File: A012/21

Applicant: Paradise Homes Kleinburg Inc.

Address: 130 Factor Street, Kleinburg

**Minor Variance
Application**

SITING AND GRADING PLAN

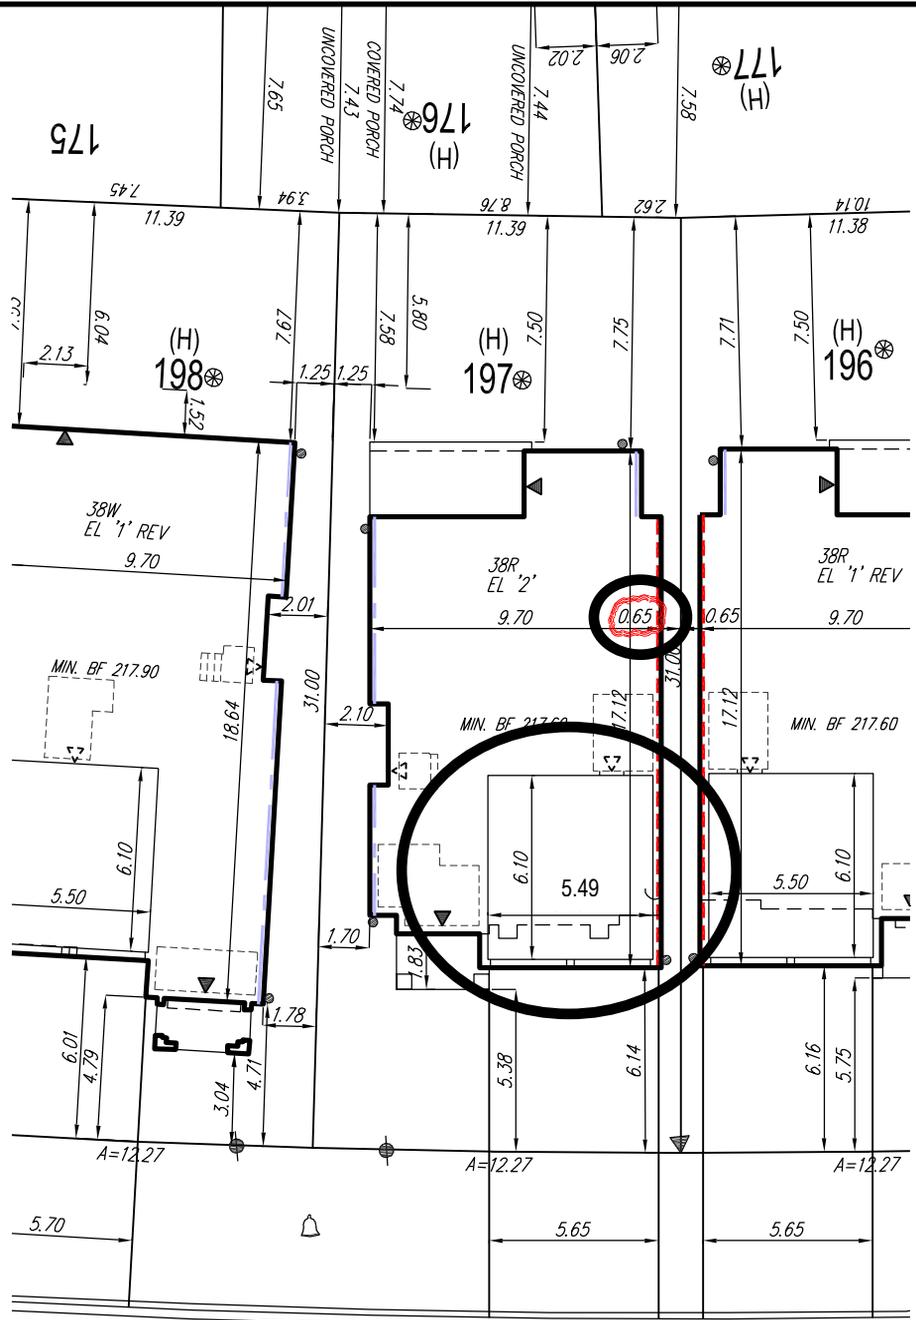
The Owner is requesting permission to construct a garage (attached to a dwelling) with a minimum interior garage dimension of 5.49m (W) by 6.10m (L) and an interior side yard setback of 0.65m. As required by the subdivision agreement and acknowledged by the Owner, maintenance easements will be registered on the interior side yard setbacks that are less than 1.2m.

Please note Development Engineering (DE) Department does not have any objection to permit side yard setback of 0.65m, when the by-law requires 1.2m but may the owner/applicant be aware that the side yard with reduced setback can only be used for drainage purpose, not for anything else.
